STATE OF VERMONT AGENCY OF TRANSPORTATION

PROPOSED IMPROVEMENT BRIDGE PROJECT TOWN OF HARTLAND COUNTY OF WINDSOR

RECORD PLANS	
CONTRACTOR:	KUBRICKY CONSTRUCTION CORP. - WILTON, NY
RESIDENT ENGINEER:	DARYL BASSETT
CONSTRUCTION BEGAN:	JUNE 10, 2014
CONSTRUCTION COMPLETE:	NOVEMBER 5, 2014
RECORD PLANS BY:	DARYL BASSETT & KEVIN KING
I HEREBY CERTIFY THAT ALL THE CONSTRUCTION REQUIRED BY THIS SET OF DRAWINGS HAS BEEN ACCOMPLISHED AS INDICATED HEREIN.	
BY	RESIDENT ENGINEER
DATE	2/22/16
NOTE: Any further information concerning final quantities, amounts or other details relative to this project may be found by contacting Vtrans Records Management.

US ROUTE 5 (MAJOR COLLECTOR), BRIDGE NUMBERS 62A AND 66

TYPICAL BRIDGE SECTION
 SCALE: 1/2" = 1'-0"

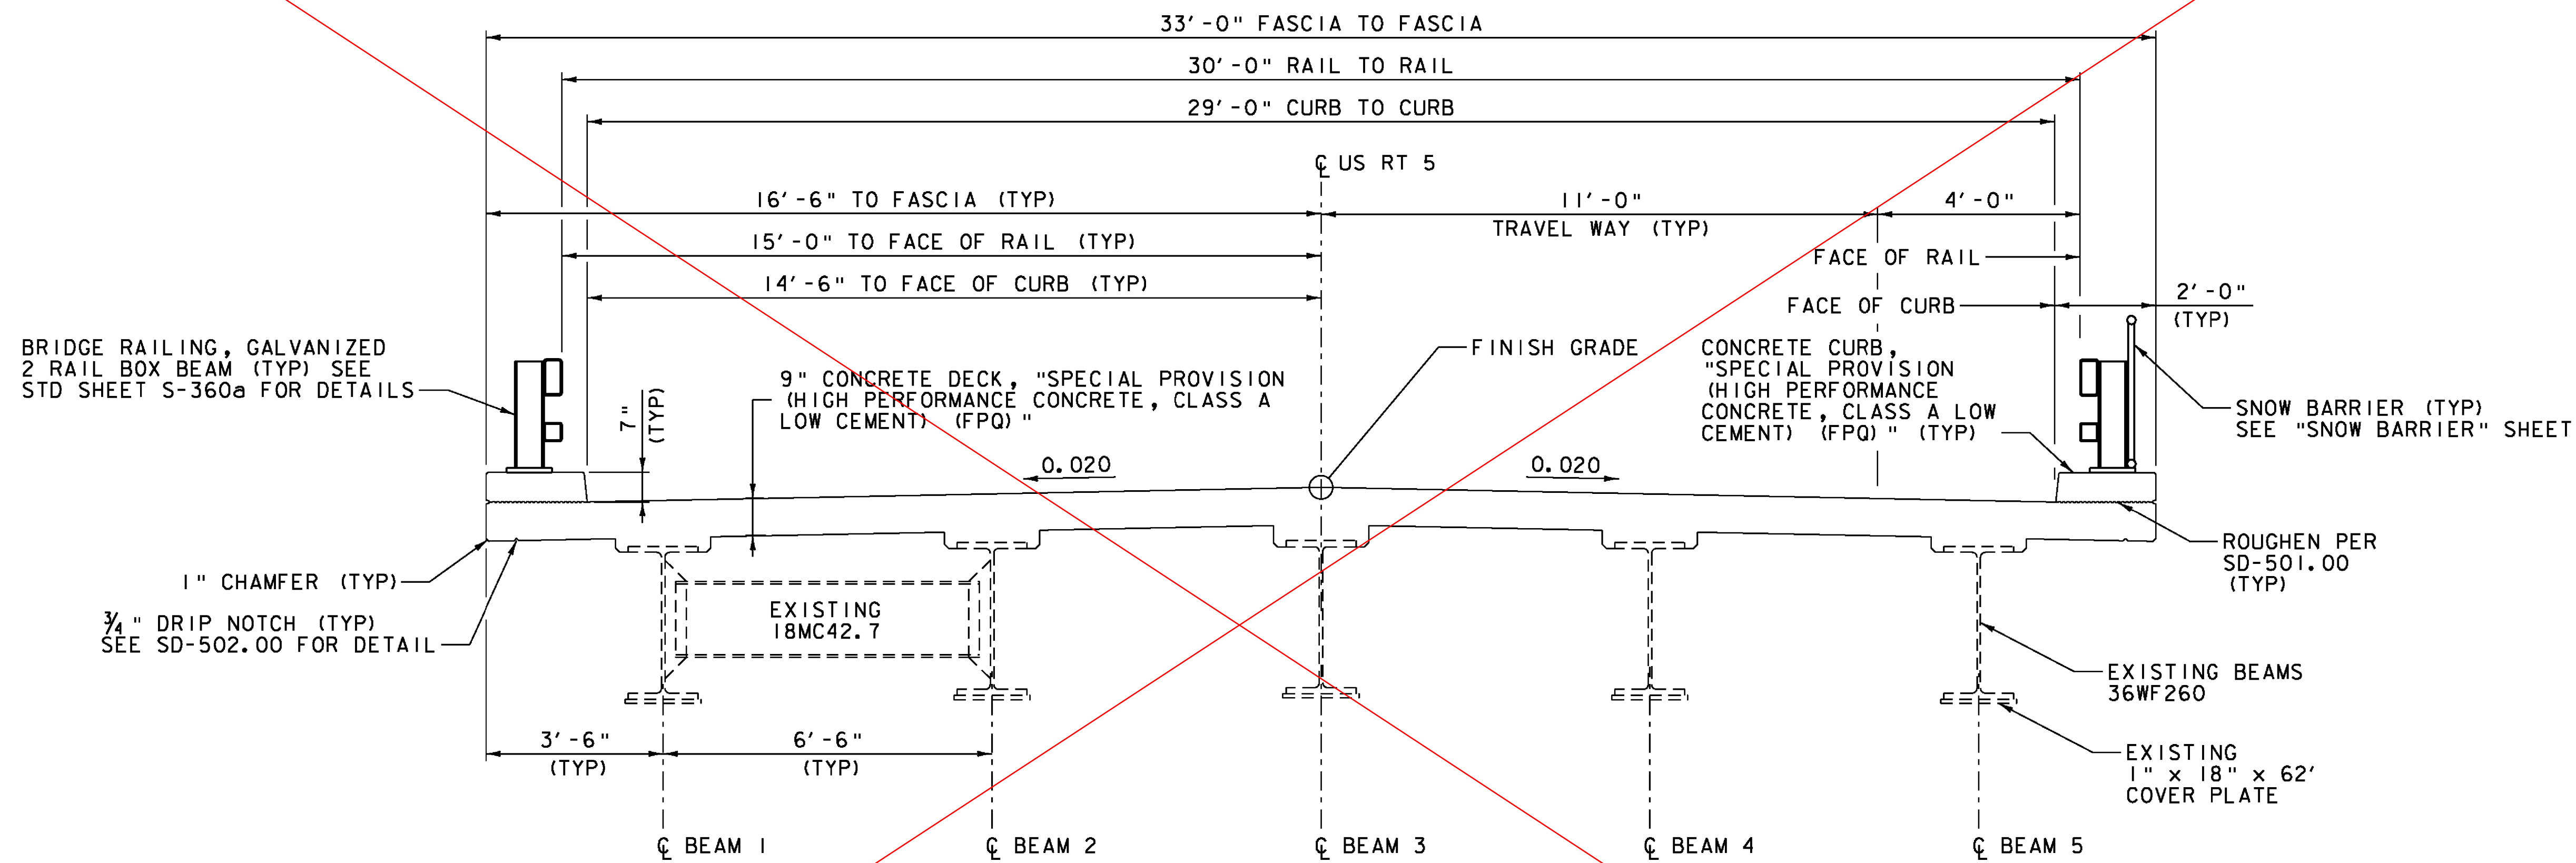
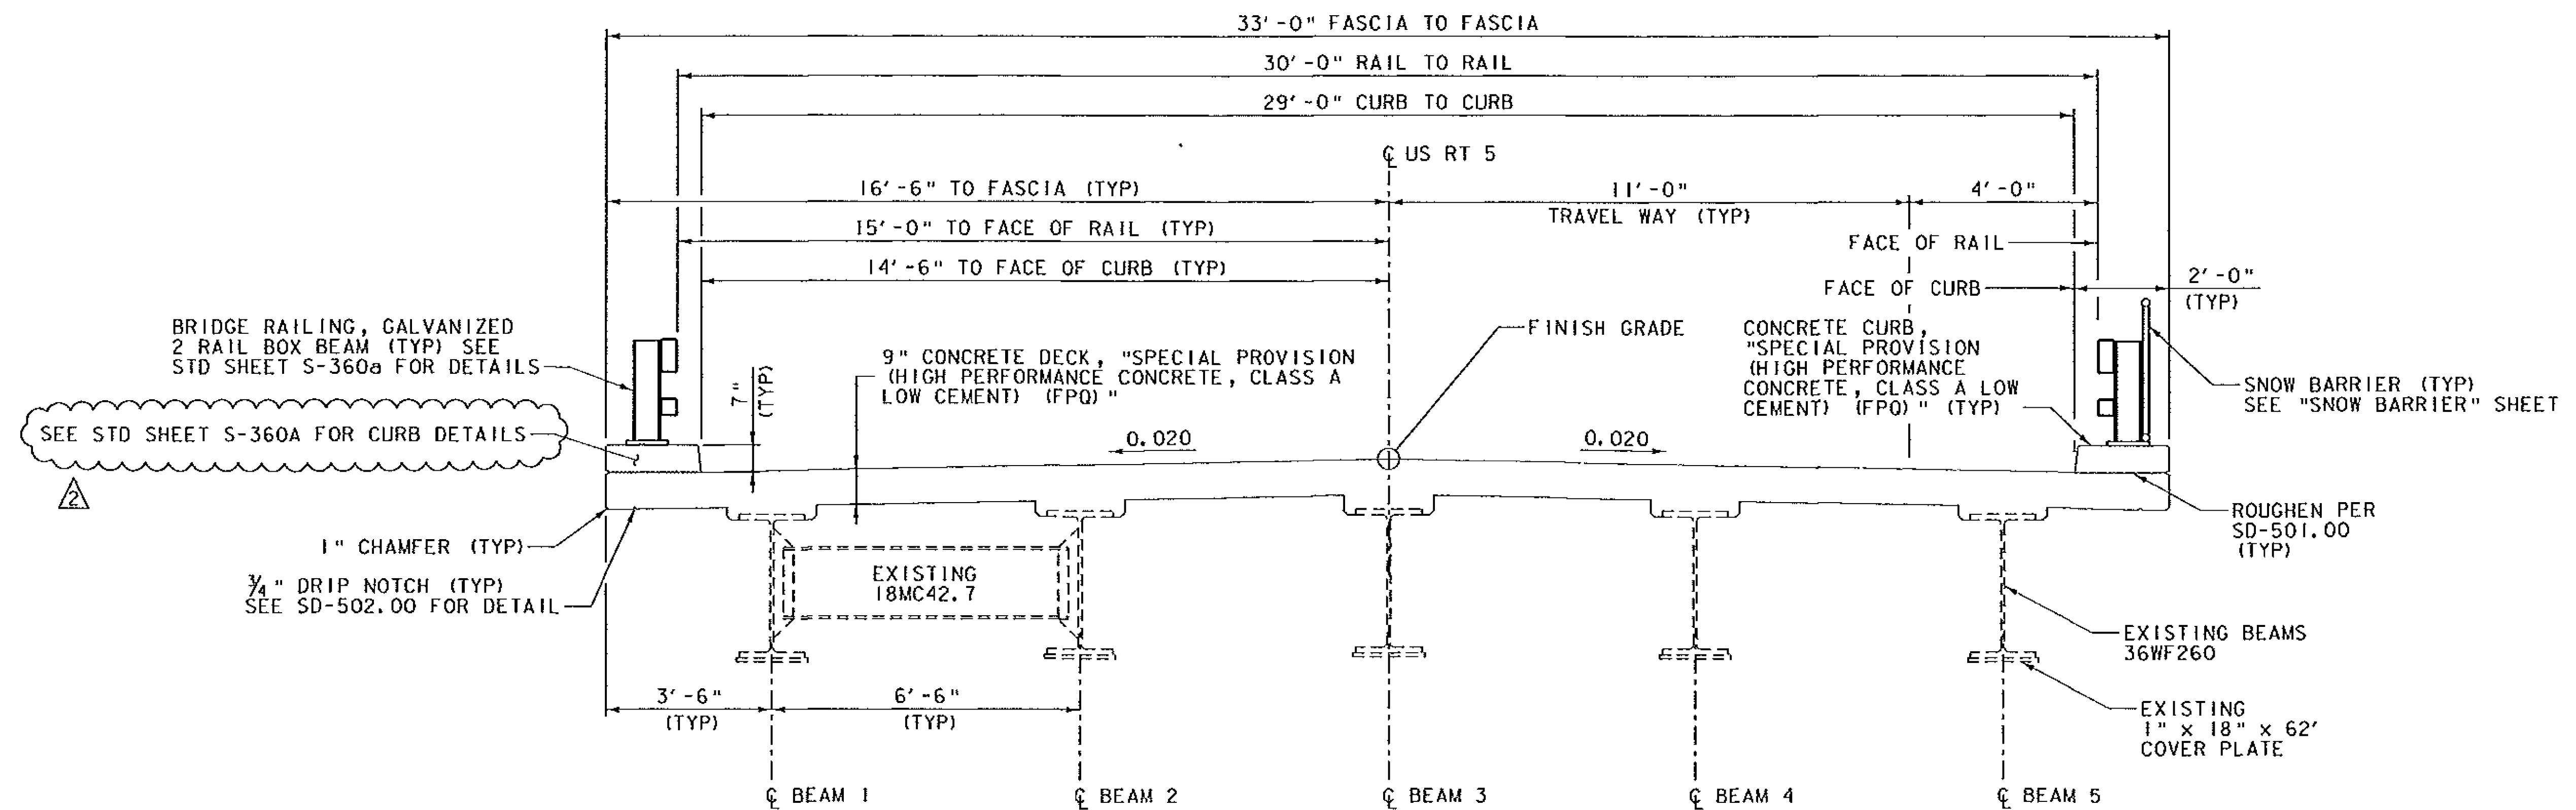
REV.	DESCRIPTION	DATE
△	SEE CURB DETAILS STD SHEET	3/3/2014
PROJECT NAME: HARTLAND		
PROJECT NUMBER: BHF BPNT(12)		
FILE NAME: zllc260typ.dgn		PLOT DATE: 3/3/2014
PROJECT LEADER: M.A. COLGAN		DRAWN BY: A.J. GOUDREAU
DESIGNED BY: A.J. GOUDREAU		CHECKED BY: S.G. FARNSWORTH
BR 62A TYPICAL BRIDGE SECTION		SHEET 3 OF 55
